**SERVICE BULLETIN #9**

**SUBJECT:** Flaperon hanger rib  
**TO:** KITFOX MODEL I, II, III owners  
**FROM:** Denney Aircraft Company

**Attached Drawing D28002 Wing Rib Reinforcement**

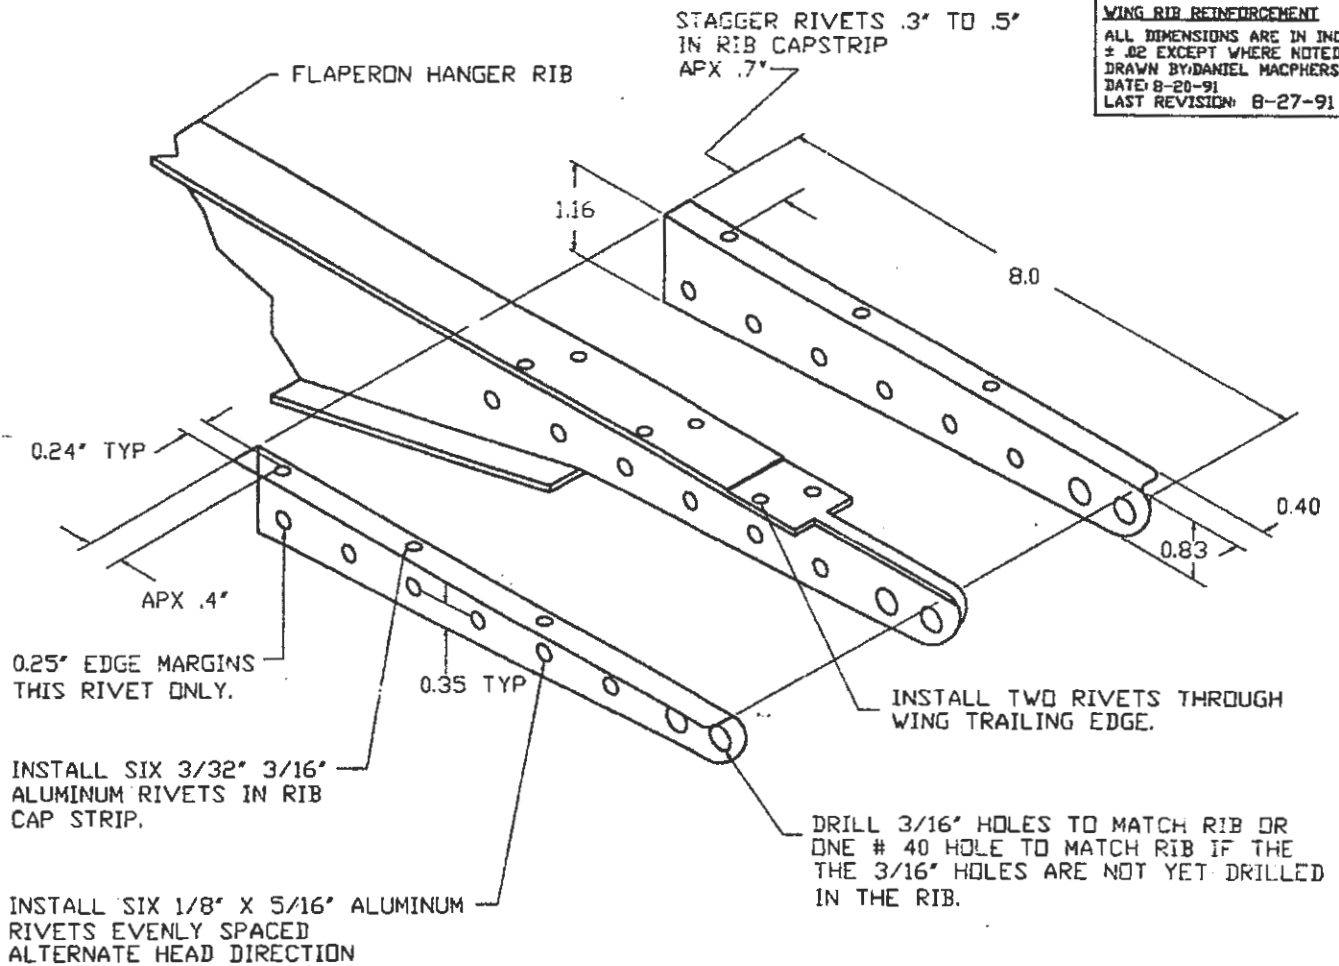
We have designed and tested reinforcements for the flaperon hanger ribs that can be readily fitted to Kitfox wings under construction or retro fitted to wings already completed. These modified ribs will withstand up to 150 lbs side load each when in reality the load will most likely be spread over the 5 hanger ribs. FAR 23 requires a side load capability of 12G's and 24 G's normal to the plane of the control surface. The flaperon with the Denney Aircraft mass balance weighs 7 pounds so you can see that it will withstand a side load of over 21 G's with the modification. We also tested standard un-modified ribs and they withstood 90 lbs of side load (12G's). In essence they met the Part 23 requirement for side loads without the reinforcement.

To meet the requirements of FAR 23 for in-plane loads of 24 G's the reinforcement must be installed on the two outboard ribs. (This assumes you have positioned your Denney Aircraft Co supplied mass-balance in the prescribed position near the outboard end of the flaperon). You should also install the reinforcement on each inboard rib to compensate for slack in the bearing or failure of the fuselage/turtledeck support bearing. If you desire to reinforce all ten flaperon hanger ribs that is ok but not necessary UNLESS you have installed the rod type mass-balance inserted in the leading edge of the flaperon as some have done in the U.K. If you have used the rod-type mass balance method then you should reinforce all 10 flaperon hanger ribs.

The reinforcements consist of left and right .025" 2024-T3 aluminum angles riveted to each side of each flaperon hanger rib end. Each angle is 8 inches long and tapers from a depth of 1.2 inches to .8 inches with a flange of .4 inch. This flange fits flush against the bottom of the rib capstrip. The reinforcement angles are fastened to the tail of each hanger rib with 6 each 1/8 inch x 5/16 inch long blind "POP" rivets. Each aluminum angle is also riveted to the rib capstrip with 3 each 3/32 inch x 3/16 inch rivets. The builder will have to round the ends of each reinforcement angle to match the rib. He can at his option apply FSA-2 structural adhesive or the equivalent to the mating surfaces for increased joint strength. If this is done the reinforcement angle should be cleaned with acetone or MEK and rough sanded with 100 grit sandpaper.

To retrofit the reinforcement strips to a wing that is already covered, you will have to slit the fabric from the trailing edge about 8 inches forward along the centerline of the bottom of the hanger rib. Slit the fabric along the trailing edge about 6 inches on each side of the rib. Then you can pull the flap of fabric back away from the rib so you can drill rivet holes and install the reinforcement angles.

To repair the fabric you will have to remove the paint and dope down to bare fabric with Stits reducer, MEK, or other suitable solvent. Then use fabric tape to cover the slits and use Stits Poly-Tac, Poly-Brush, and Poly-Spray to attach and coat the tapes. Heat-shrink the patches and repaired areas to restore tautness to those areas. Repaint.
